# FINAL DRAINAGE REPORT

## DEYOUNG SUBDIVISION BENT GRASS MEADOWS DRIVE

### Engineering Review

JPS Project No. 031901  
PCD Project No. MS-20-001

**PHASE 1 DEVELOPED DRAINAGE PLAN**

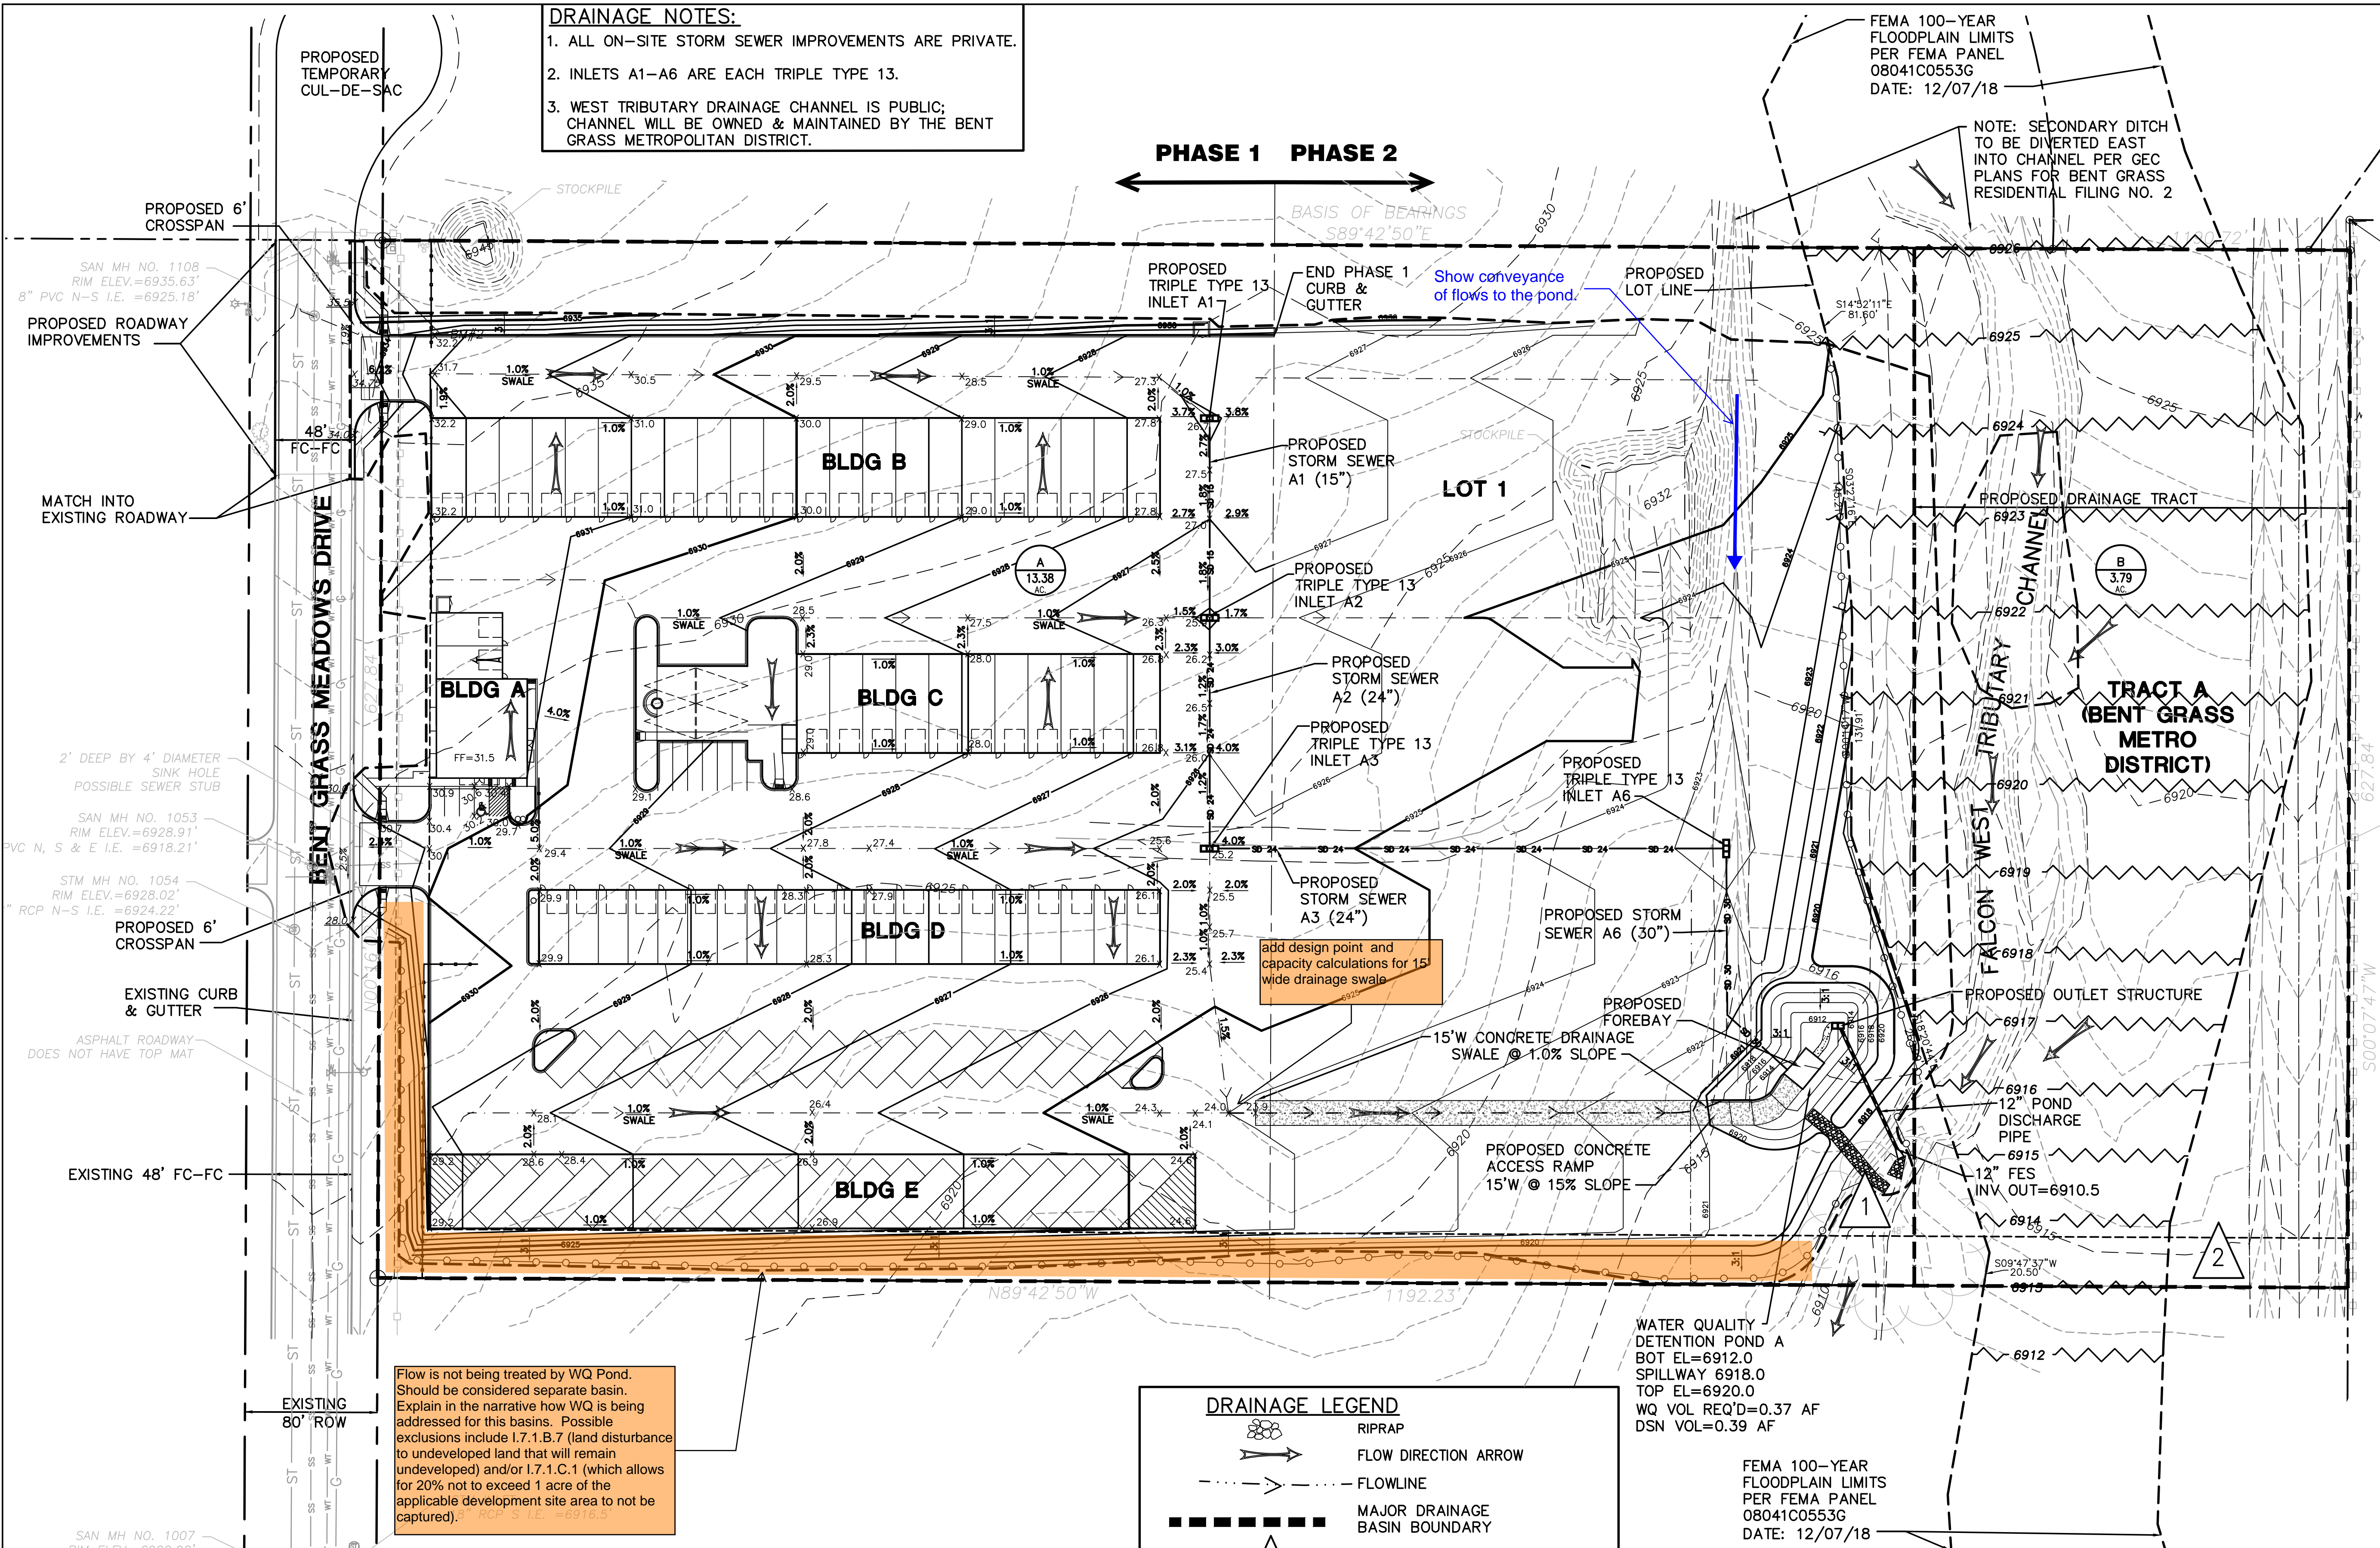
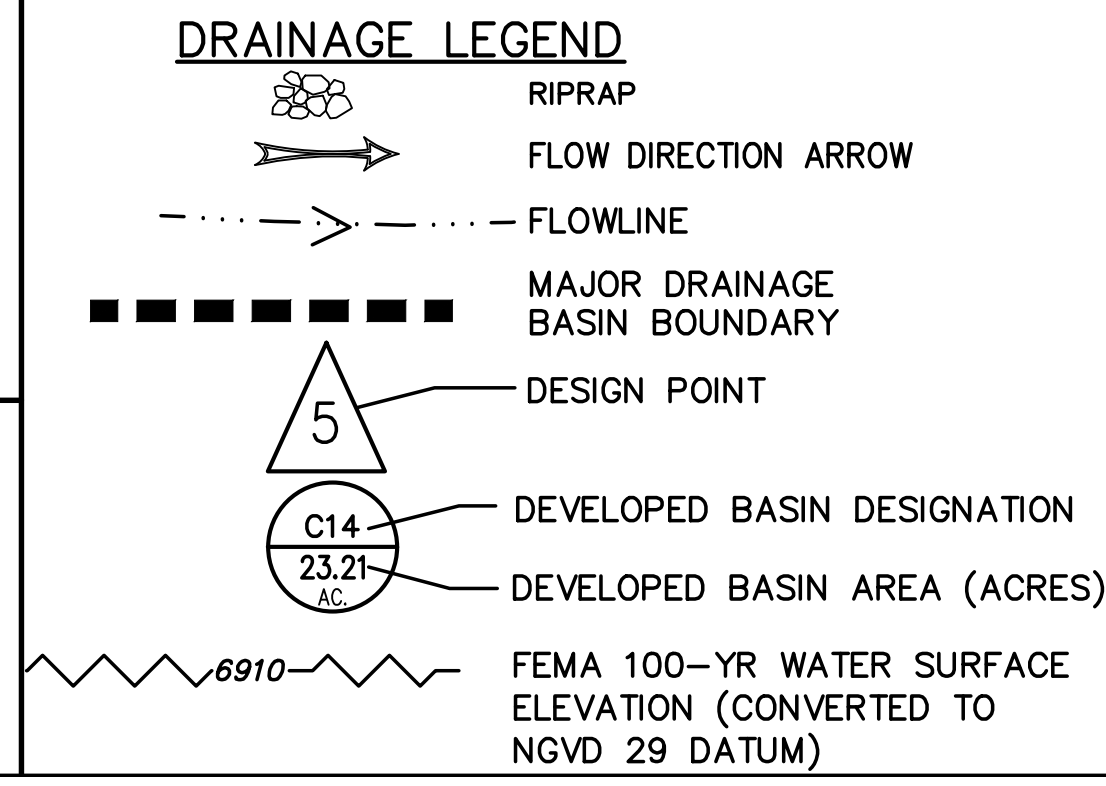
Flow is not being treated by WQ Pond. Should be considered separate basin. Explain in the narrative how WQ is being addressed for this basins. Possible exclusions include I.7.1.B.7 (land disturbance to undeveloped land that will remain undeveloped) and/or I.7.1.C.1 (which allows for 20% not to exceed 1 acre of the applicable development site area to not be captured).
